September 22, 2021

Topic: ENERGY STAR® Version 5.0 Commercial Refrigerators and Freezers Draft 1 Specification

Figure 1: Daily Energy Consumption (DEC) and refrigerated volume⁵ of chef base refrigerators (CB.SC.M) from various sources.

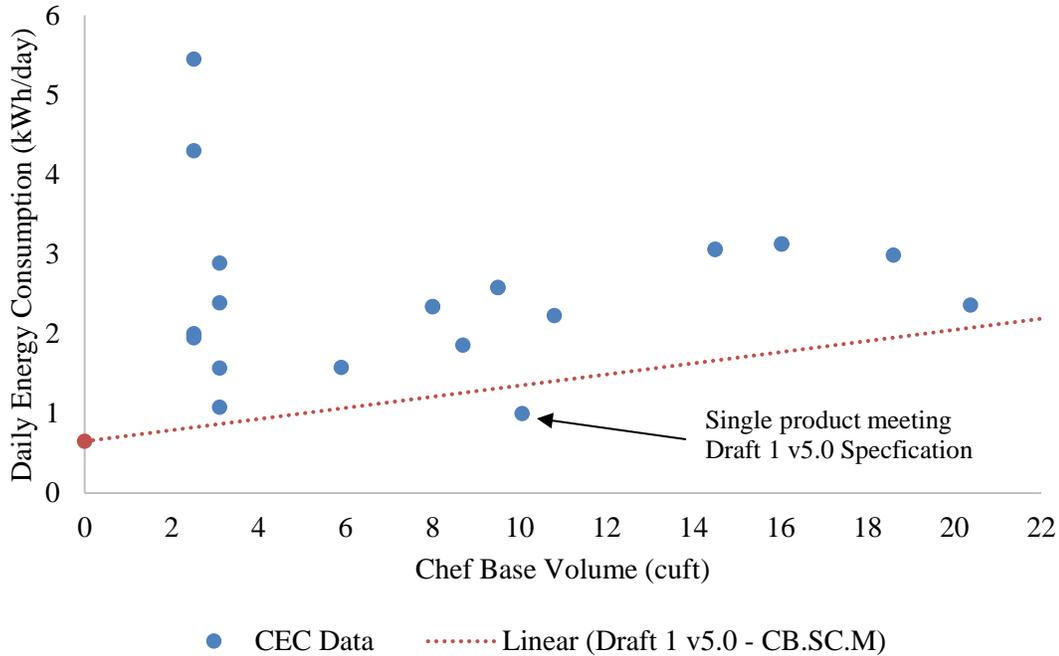
We applaud ENERGY STAR for including chef base refrigerators (CB.SC.M) and chef base freezers (CB.SC.L) as new product categories under the Version 5.0 Draft 1 Specification. Our analysis of publicly available data sources suggests that the CB.SC.M and CB.SC.L levels may not meet ENERGY STAR’s program goal of representing 25 percent of equipment on the market with the highest energy efficiency performance. A 2016 study by SCE demonstrated significant variation in energy consumption among six different products in the CB.SC.M category, representing a sizeable energy savings opportunity.³ However, those six models tested by SCE stood out significantly from the rest of the data used to generate the specification. EPA has indicated that the specification level was determined through a combined analysis of data from chef bases, refrigerated worktops, and undercounter refrigerators, but both refrigerated worktops and undercounter refrigerators generally use less energy per volume than chef bases, as EPA has acknowledged in the performance data.⁴ After filtering the California Energy Commission’s Modernized Appliance Efficiency Database System (MAEDbS) data for chef bases only, we found only one chef base model would qualify under the current proposed standard (see Figure 1 below).

While the MAEDbS does not provide a full view of the market for both CB.SC.M or CB.SC.L, we nonetheless suggest an additional review of the specification levels to ensure the final specification accomplishes ENERGY STAR’s product representation goals for both product categories.

Figure 2: Top-down and side view of chef bases currently on the market with non-useable volume highlighted in red.

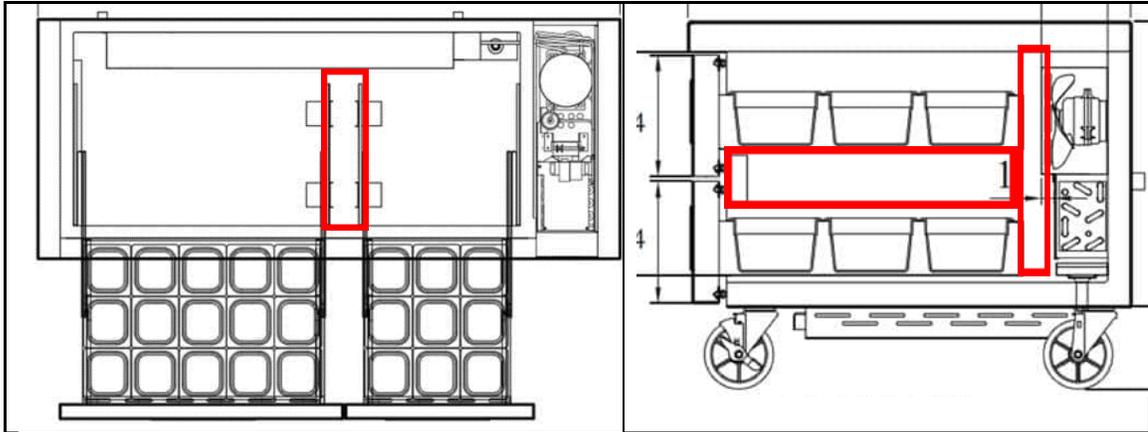
Further, we suggest further clarification about the methodology for determining the internal volume of chef bases, which is not clearly defined in the most current ASHRAE Standard 72 (2018). The volume of the refrigerated space within chef bases can be interpreted in two ways: usable volume and total volume, including both usable and non-usable volume. The distribution of usable and non-usable volume is based on drawer placement. The interpretation of refrigerated volume can have a sizeable impact on the energy consumption criteria. As such, we recommend

normalizing energy use based on usable volume to ensure that units with large volumes of non-useable refrigerated space do not have more lenient energy criteria compared to more space-efficient designs that offer the same functionality to the customer. Figure 2 below highlights such areas of significant non-useable volume within existing product diagrams.
